**SPECIAL CERTIFICATE OF APPROPRIATENESS
SCA2025-00028 11226 MATLACHA AVENUE**

**LEE COUNTY HISTORIC PRESERVATION BOARD
JANUARY 15, 2026**

PROJECT ADDRESS: 11226 Matlacha Avenue, Matlacha, FL 33993
STRAP NUMBER: 24-44-22-03-00001.0120
DESIGNATION: Non-Contributing

The applicant requests approval to construct a new elevated residence at 11226 Matlacha Avenue. Staff finds that the proposed project does not conform to the character of the Matlacha Historic District and the community as a whole.

LEFT SIDE ELEVATION
SCALE: 1/4" = 1'-0"

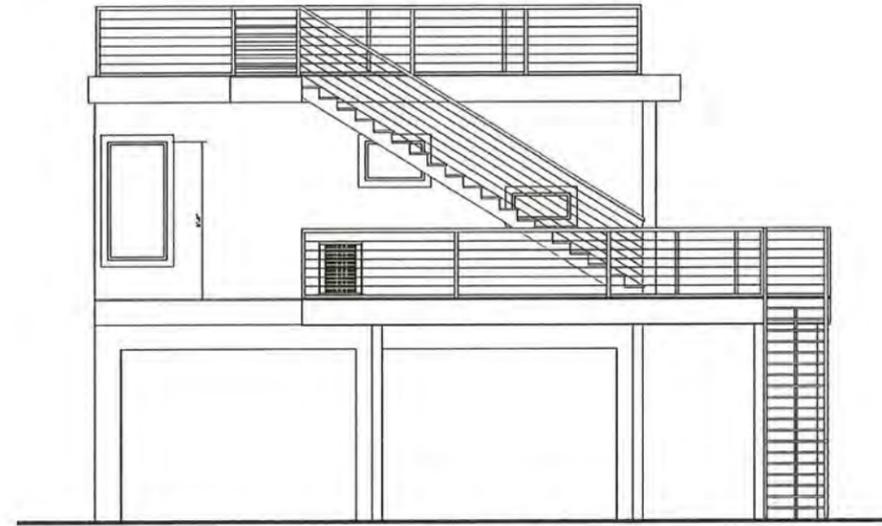
The left side (southeast) façade faces onto Matlacha Avenue. It will have an open ground floor with only the support columns. The upper floor will have three windows. There will be a single hung window at one end and two smaller fixed windows in the façade. The staircase from the upper floor to the roof deck runs along this façade.

FRONT ELEVATION
SCALE: 1/4" = 1'-0"

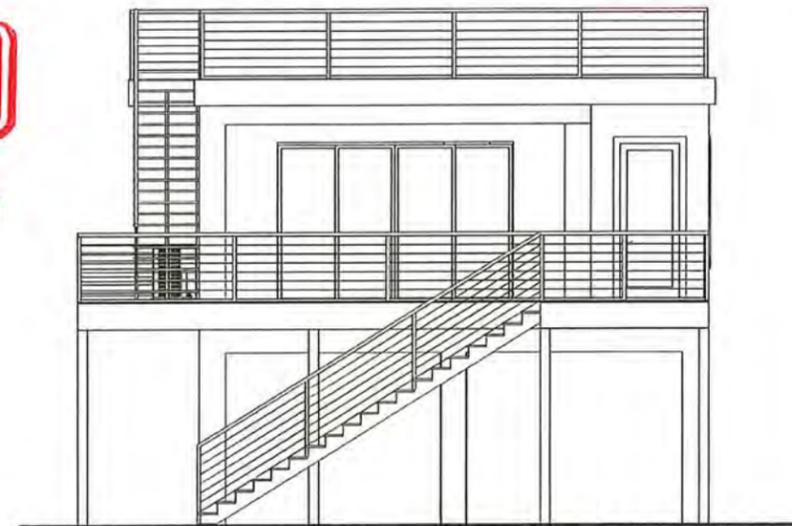
The front (southeast) elevation does not face Matlacha Avenue, but rather, is at a right angle to the street. The ground floor on this façade is occupied by the access stairs. It is otherwise open apart from the support columns. On the upper floor, the main entrance will be located at the northeast corner of the façade, and double sliding glass door in the middle of the façade. The façade will be topped with the roof deck railings above.

REAR ELEVATION
SCALE: 1/4" = 1'-0"

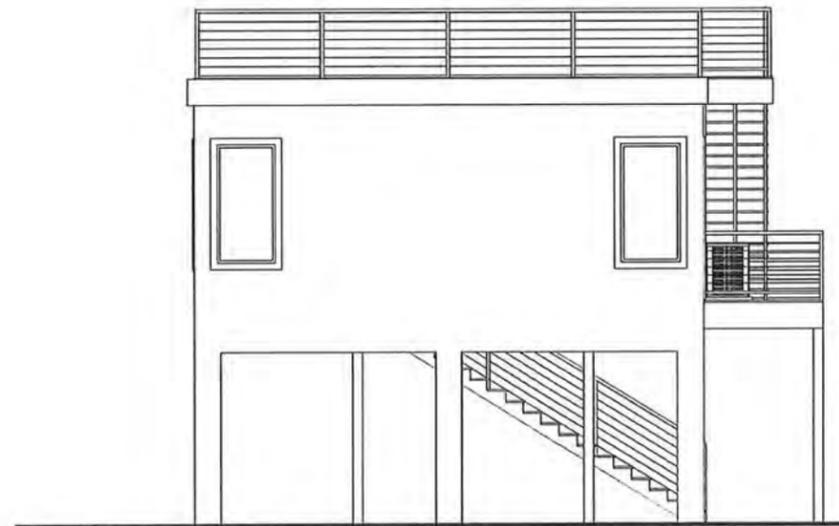
The rear (northwest) elevation will have an open ground floor with only the support columns visible. On the upper floor, there will be two identical narrow, vertical windows on the façade, one near each edge of the façade. Both of the windows will be single hung style. The end of the upper floor deck is also visible on this façade. The façade will be topped with the roof deck railings above.

RIGHT SIDE ELEVATION
SCALE: 1/4" = 1'-0"

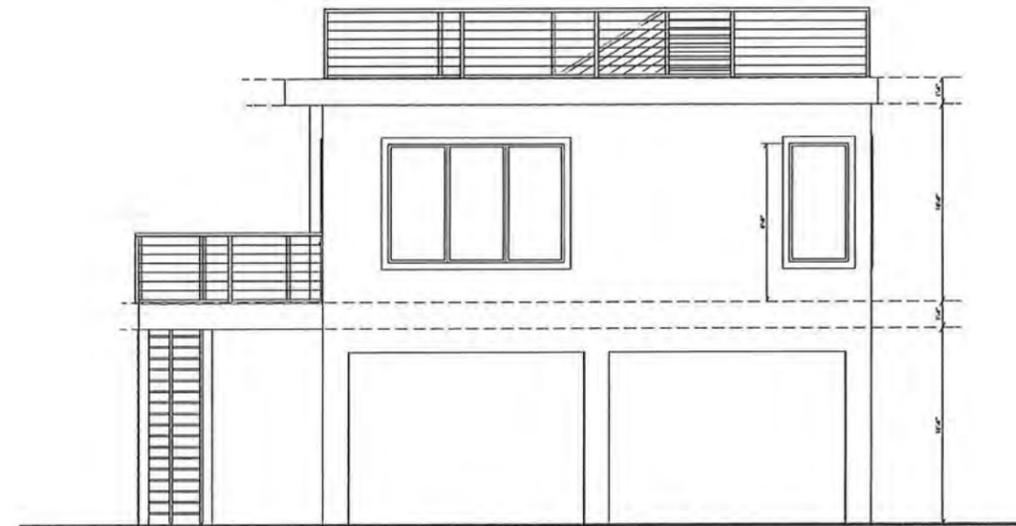
The right side (northwest) façade faces towards the canal and is open on the ground floor with only support columns visible. On the upper floor, there will be a large casement window on one side with triple lights, resembling a ribbon of three windows. At the other end of the façade will be a single hung window. The front access stairs and deck are also visible. The façade will be topped with the roof deck railings above.
